City of Fredericksburg

Historic Review Board Meeting Agenda
Tuesday, January 9, 2024 ~ 5:30 PM
Law Enforcement Center
1601 E. Main Street
Fredericksburg, Texas 78624

HISTORIC REVIEW BOARD AGENDA MEMO

HISTORIC REVIEW BOARD AGENDA MEMO

Stone fence location, setback minimum 25ft from road

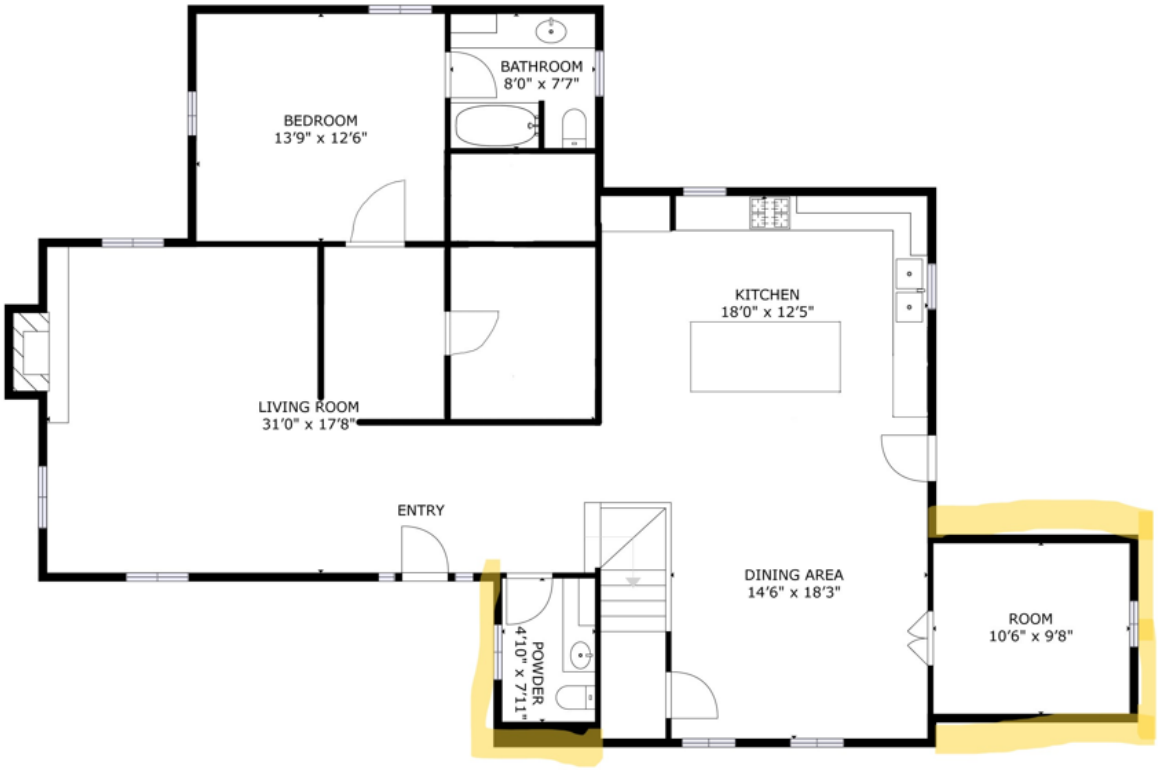
STAFF RECOMMENDATION:
Staff find the stone wall would disrupt the openness of front yards in the immediate neighborhood. A historic house across the street has a single row of stones laid out as a permiter, however there are no other front yard walls. Fences or walls are typical for defining side and rear yards.

SHEET:
SITE PLAN

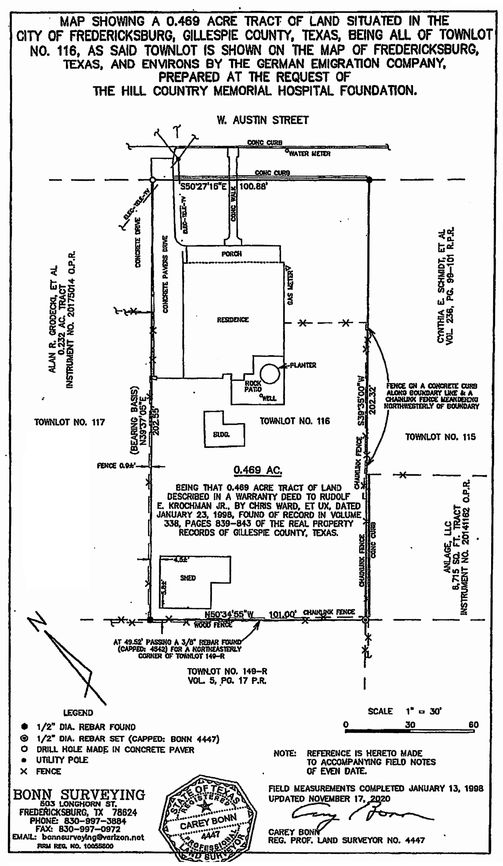
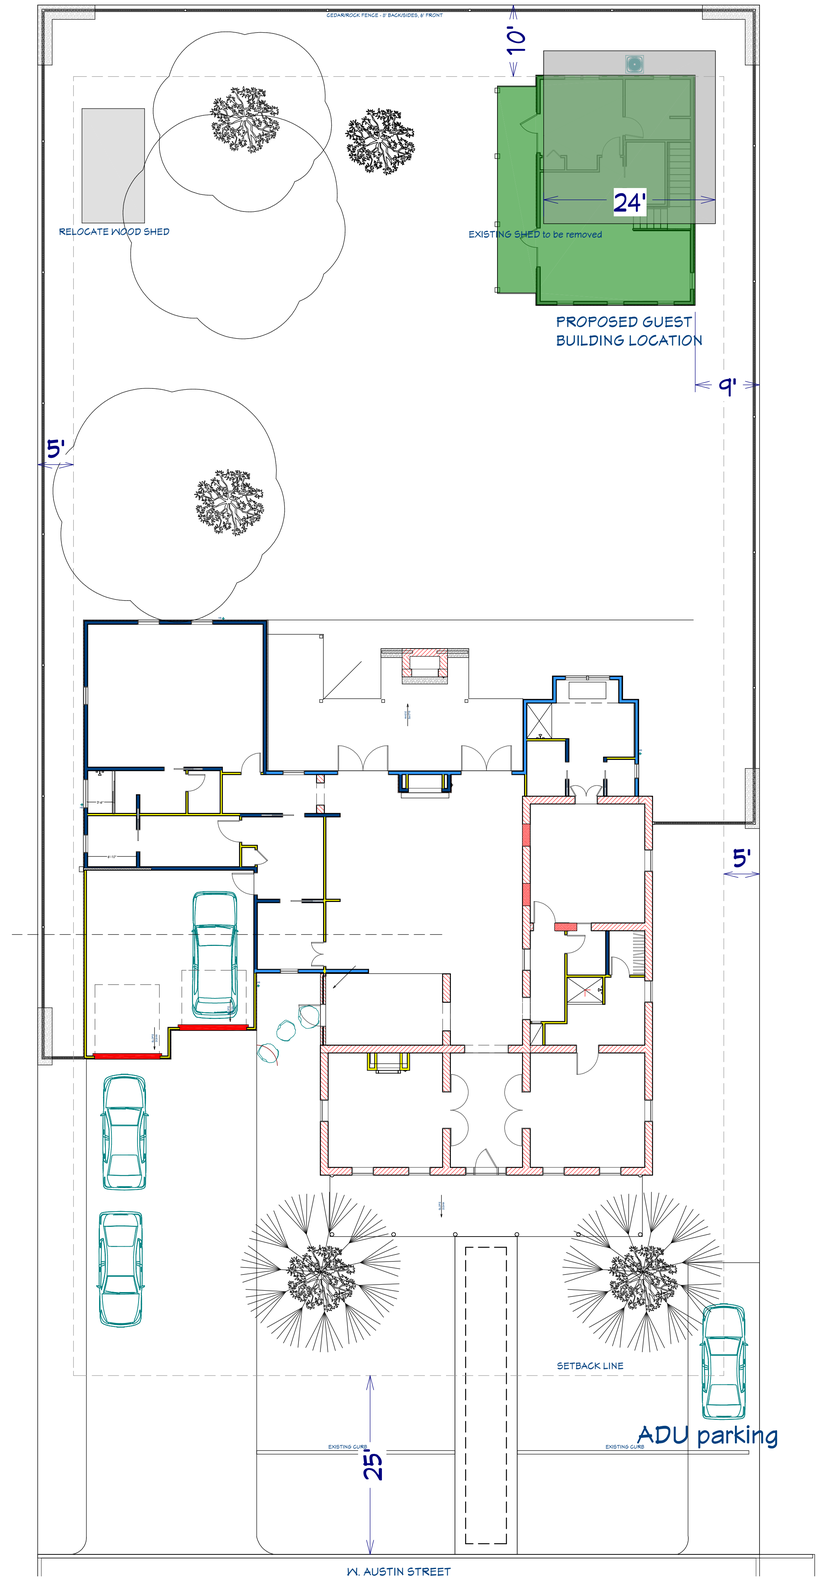
STAFF RECOMMENDATION:
1.Staff was able to conduct a site visit to asses the condition of the structure. It is not as old as the main house, but has likely been in place for more than 50 years. Outbuildings tell an important part of Fredericksburg history and should be retained whenever and wherever possible.The structure in question is a typical barn/garage structure that is built with cedar posts and a mish-mash of materials. It is not of the same value as the high-rated main house. Staff recommends re-rating to "medium" rating. The metal siding and framing members are a patchwork, typical for the use and age of the building. The condition and dimensions of the building limit its ability to be re-used for anything other than storage. An adaptive re-use would require such extensive alterations that the authenticity of the nature of the building would be lost. Staff suggests the materials be dismantled and re-used on site where ever possible.

2. The requested new construction of a guest house is in the location of the old barn.It is very common for townlots to have secondary structures but they were historically smaller in size and height than the primary structure.The proposed accessory building has a footprint of approximately 700 sq which is less than the main house with its current additions, but is close to the footprint of the original house. It is taller than the main house. Staff suggests modifications be made to the new construction to reduce the height and mass of the new building to give it more of an outbuilding appearance and that materials from the demolition of the outbuilding be used where feasible.

NORTH ELEVATION

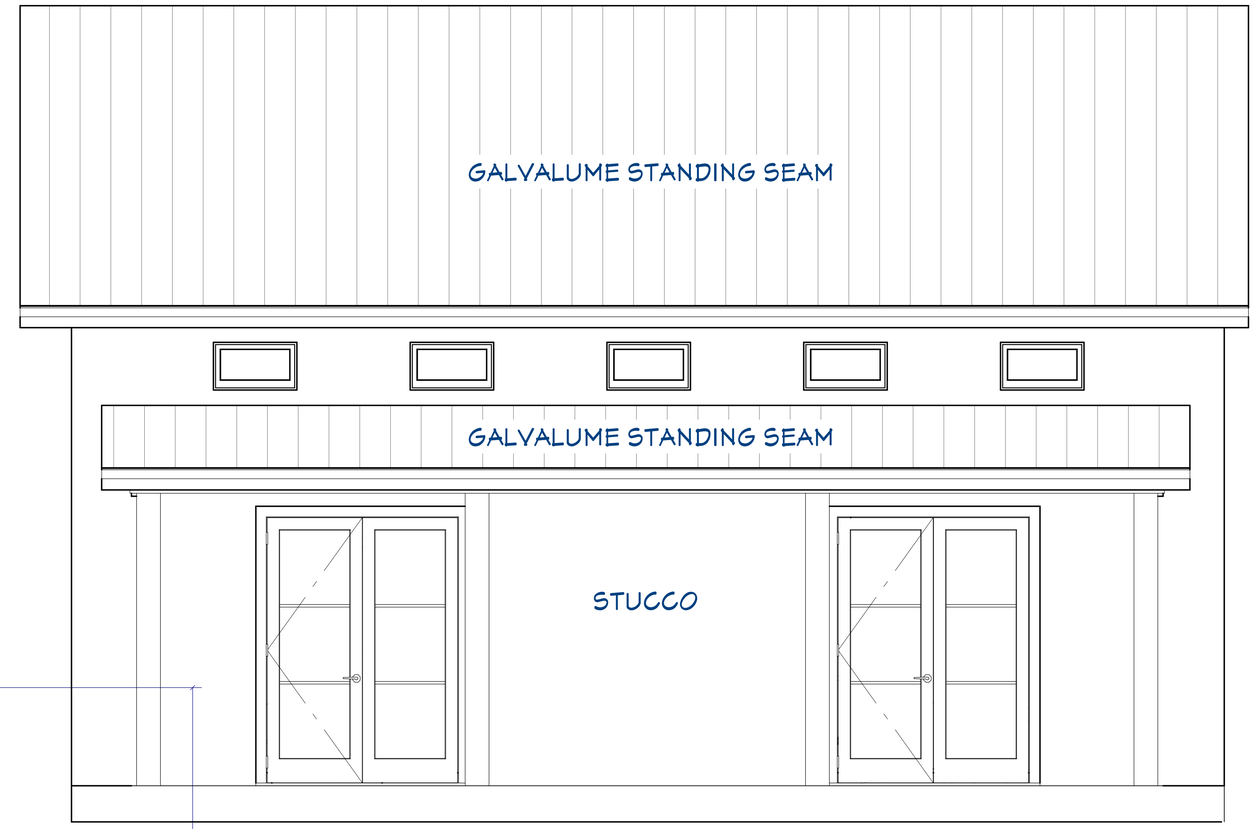
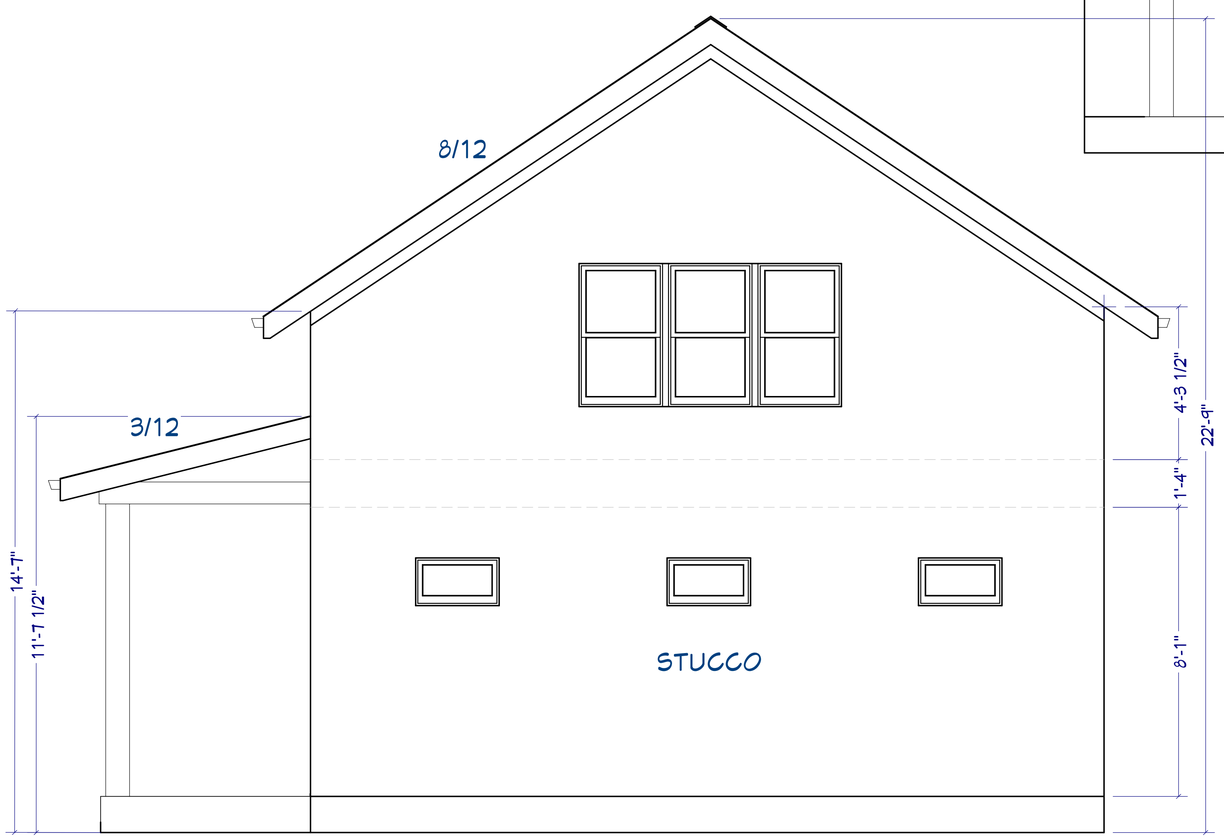
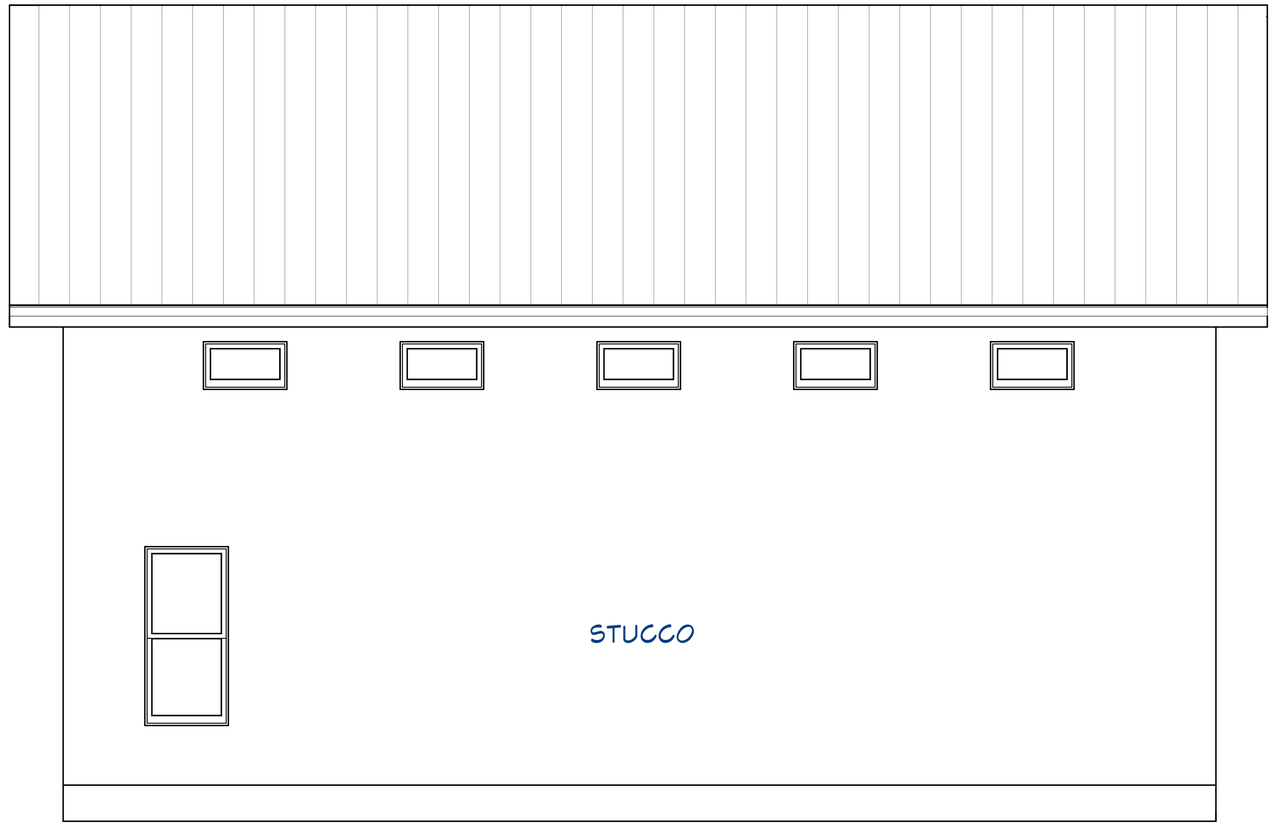
The requested new construction is appropriate in both mass and scale and follows traditional development patterns. The first design showed the barn to remain, but the new plans show the barn replaced with a modern guest house. Staff recommends a door or shed roof be added to the north elevation to give it more of a traditional accessory building appearance as it faces the street.
